TRANSMITTAL

Attention:	Jeff Williams / Dana Bernard / <i>Kevin Wolf</i>	Date	12/06/2022
Address:	8930 Standford Blvd - Columbia, MD 21045	Project Number:	3502
Phone Number:	410-313-2691	Project Name:	Kings Forest

Remarks: Please find attached the submittal package for review and approval of the Redline BAT Plan for Lot 28 at Kings Forest. This plan had to be redline to meet the field conditions per installer, this was approved by Email on 11/23/22. Any questions or comments please contact us as soon as possible. Thank you!

SITE PLAN FOR BAT INSTALLATION
LOT 28
KINGS FOREST
LIBER 11372, FOLIO 431
PLAT No. 25767
TAX No. 03-603438
2nd ELECTION DISTRICT
HOWARD COUNTY, MARYLAND
ADDRESS: 10537 PUDDING LANE
ELLIOTT CITY, MARYLAND 21042

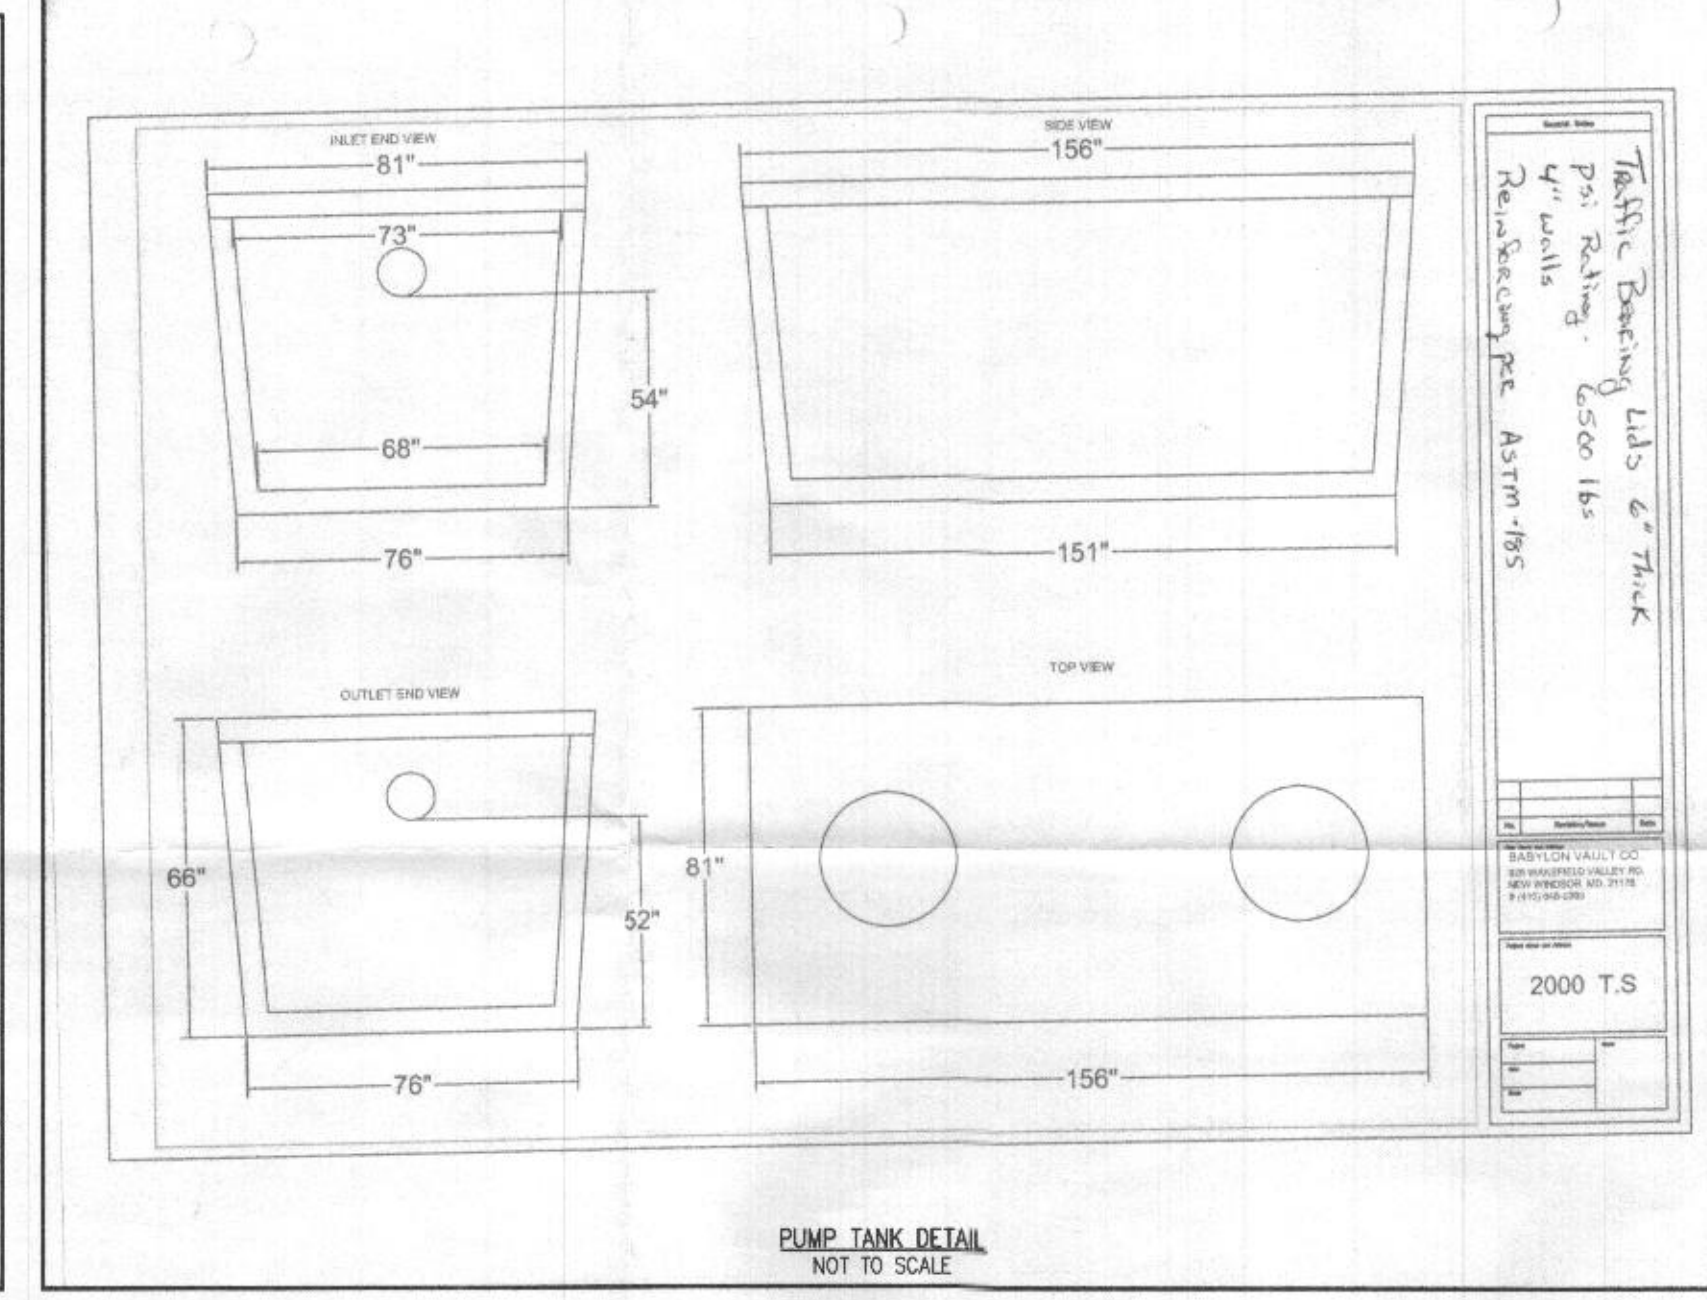
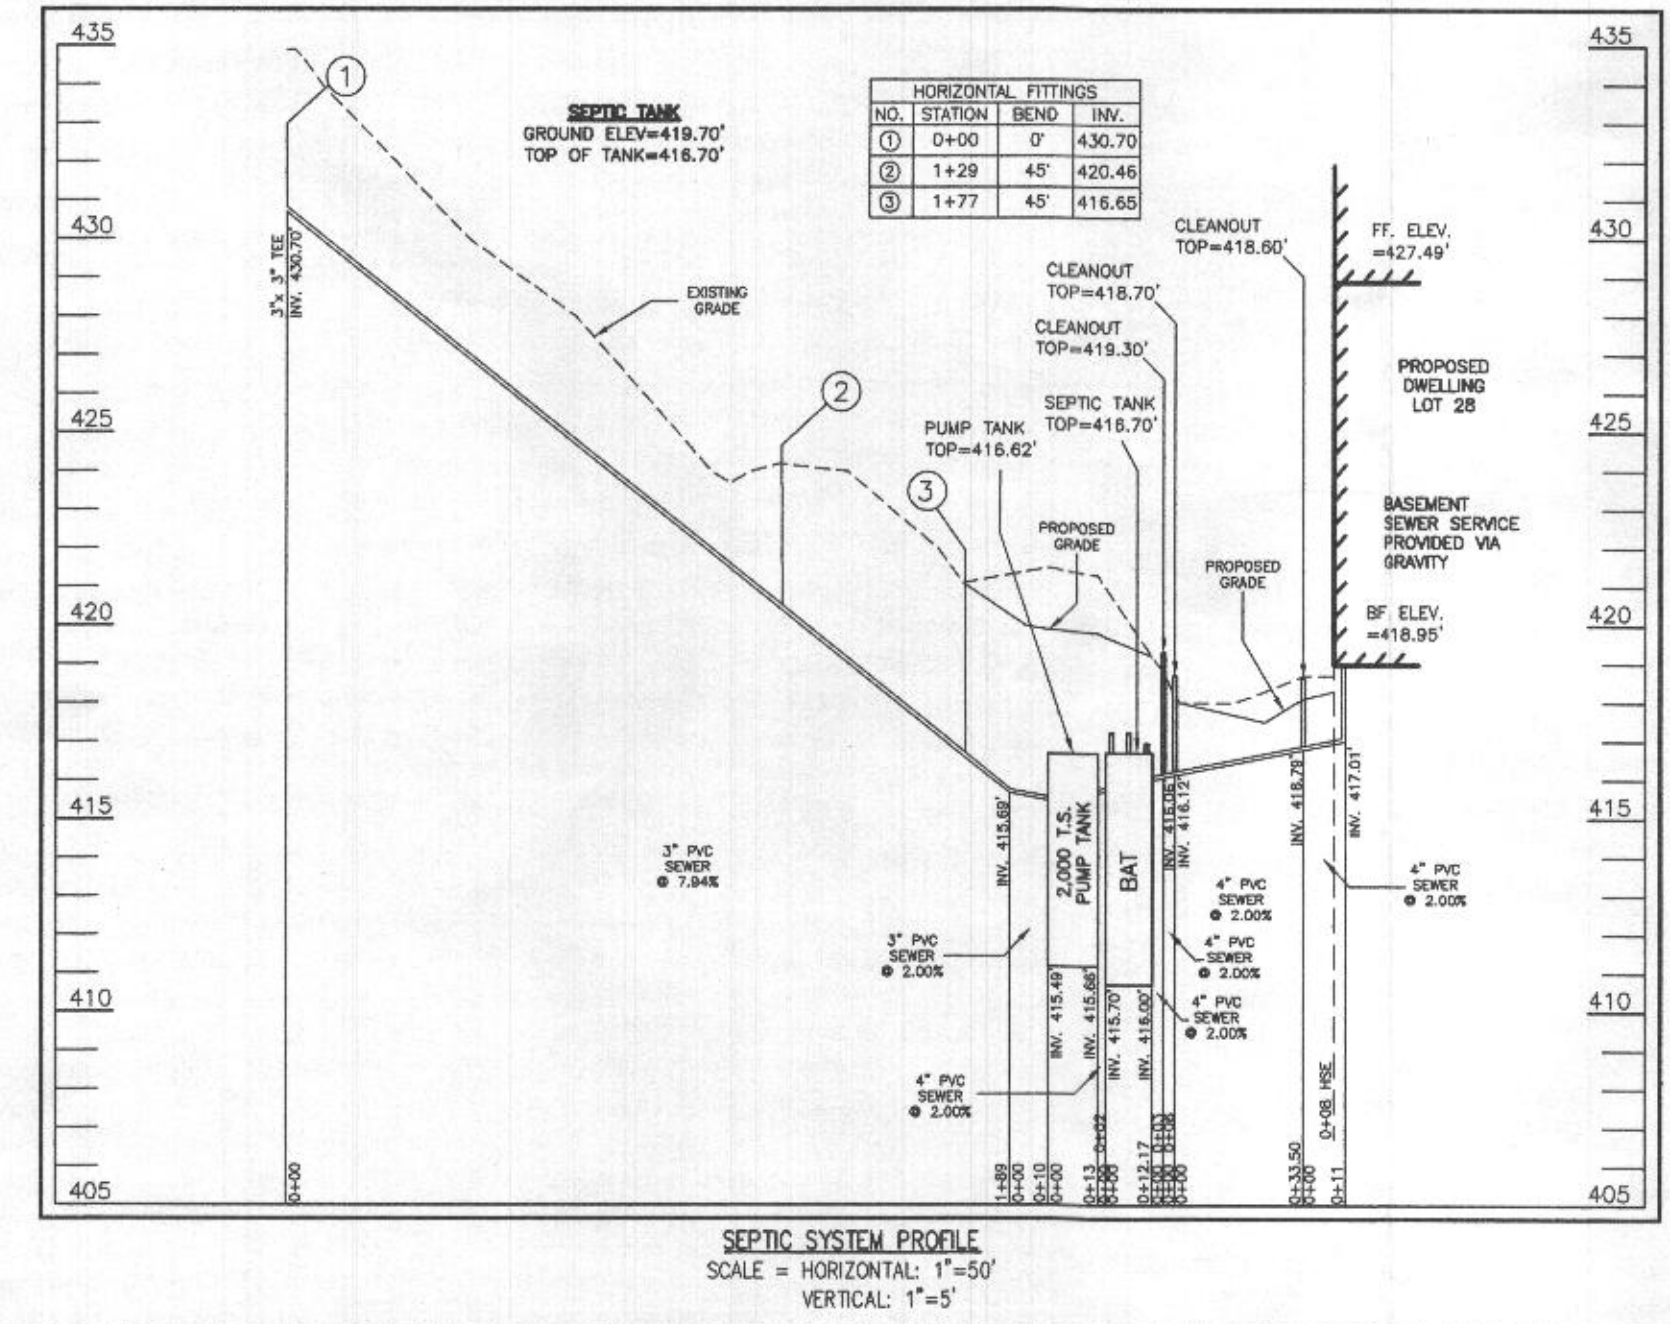
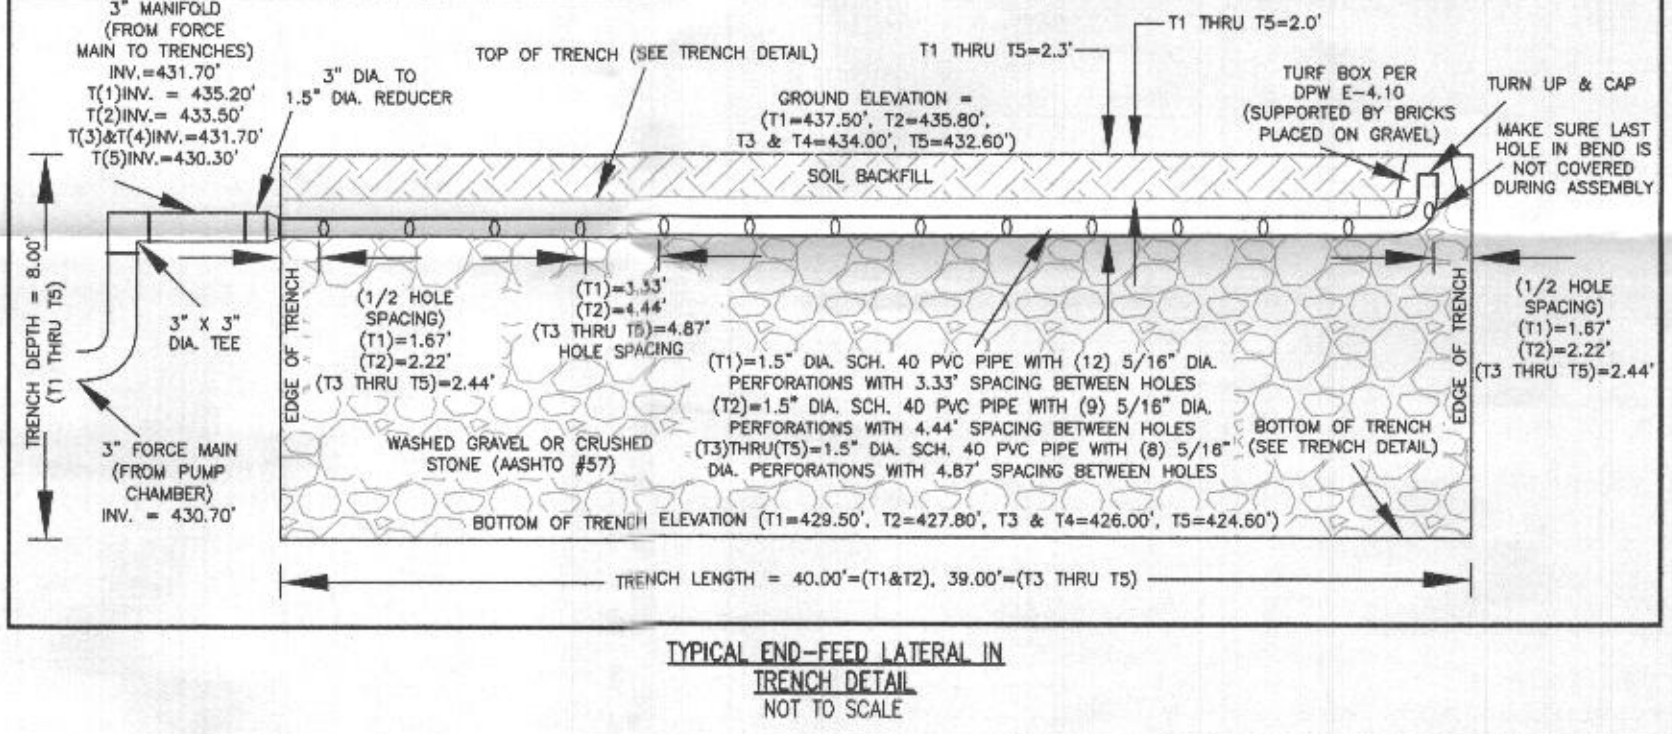
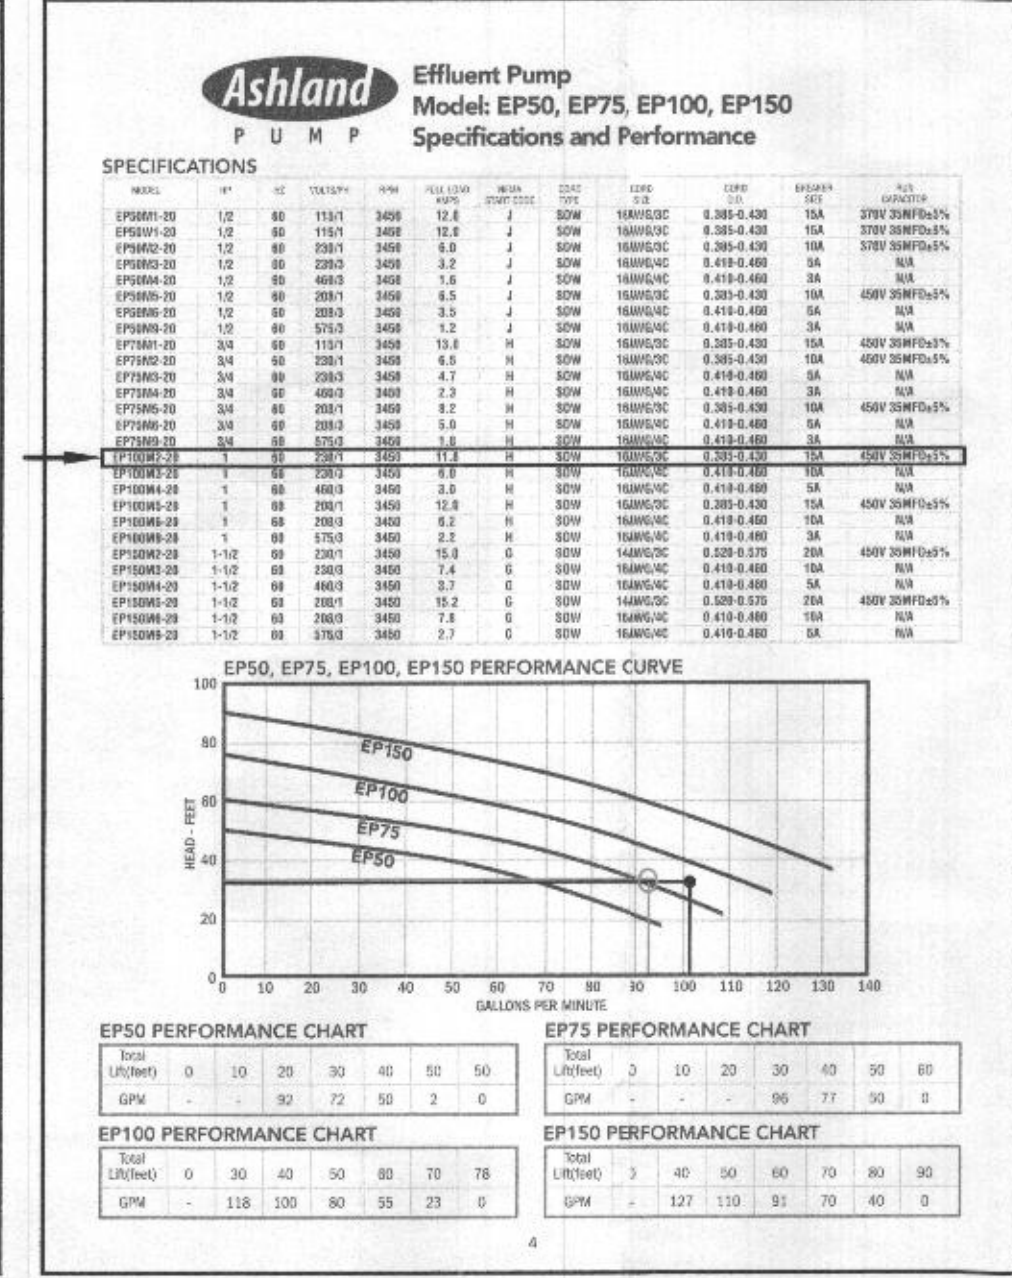
TRENCH 1 (71') 40.00 FL'
GROUND ABOVE = 437.50' 437.95'
INV. IN = 435.20' 435.74'
BOTTOM TRENCH = 429.56' 430.68'

DESIGN FLOW = 750 GPD
PUMP OFF ELEV. = 413.32' 412.39'
INV. OUT PUMP TANK = 415.49'
PUMP BOTTOM ELEV. = 414.99' 410.56'
PUMP SELECTED = 1 HP

FRICITION HEAD = 7.00' FT. (PER ABOVE CALCULATION)
OPERATING HEAD = 2.00' 1.50' FT.
STATIC HEAD = 28.88' 31.35' FEET. (HIGHEST POINT IN DISTRIBUTION SYSTEM - PUMP OFF FLAT ELEVATION)
TOTAL DYNAMIC HEAD = 35.88' 31.35' FEET. (FRICITION HEAD + OPERATING HEAD+ STATIC HEAD)

THEREFORE A PUMP CAPABLE OF DELIVERING AT LEAST 101.94 GPM AGAINST 35.88' OF HEAD IS REQUIRED.
EP100M2-20, 1 H.P. IS EFFICIENT
